INVITATION TO TENDER "ITT" No. PS20190838  
CONTRACTOR FOR THUNDERBIRD CC PRESCHOOL OUTDOOR PLAY AREA RENOVATION

**AMENDMENT No. 1**

## Addendum 01

**Project:** Thunderbird Preschool Playground  
Vancouver, BC

L1.0

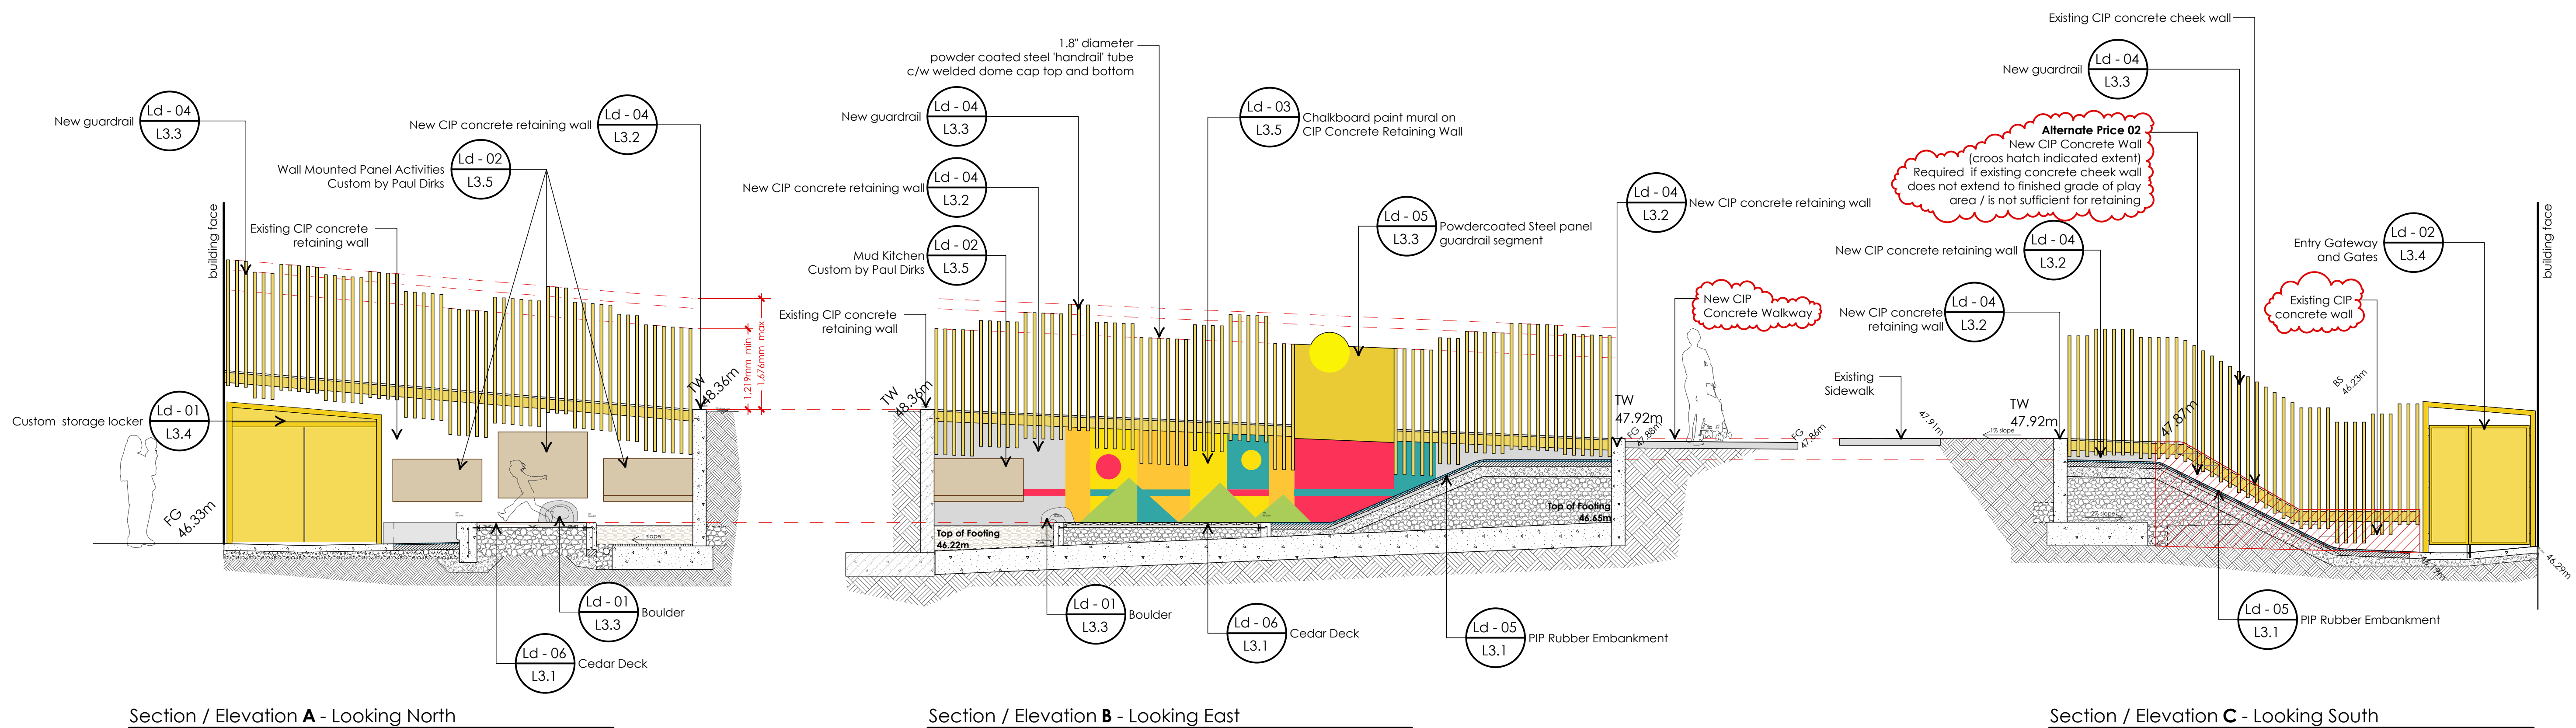
- 1.1 Remove and replace concrete walkway at top of existing stairs refer to L1.0, L1.1
- 1.2 Retain existing concrete wall at bottom of existing stairs refer to L1.0
- 1.3 Re/Re existing concrete walkway at bottom of existing stairs refer to L1.1
- 1.4 Re/Re sodded boulevard refer to L1.1
- 1.5 Revise depth of poured in Place rubber surfacing to be 50mm refer to Materials Legend on L1.1
- 1.6 Delete (1) Phyllostachys Nigra from Planting Plan refer to L1.1
- 1.7 Alternate Price 02 – Remove existing concrete cheek wall and concrete wall at bottom of existing stairs per L1.0, add new segment of 8" thick reinforced CIP concrete wall to extent shown on L1.1, L1.2
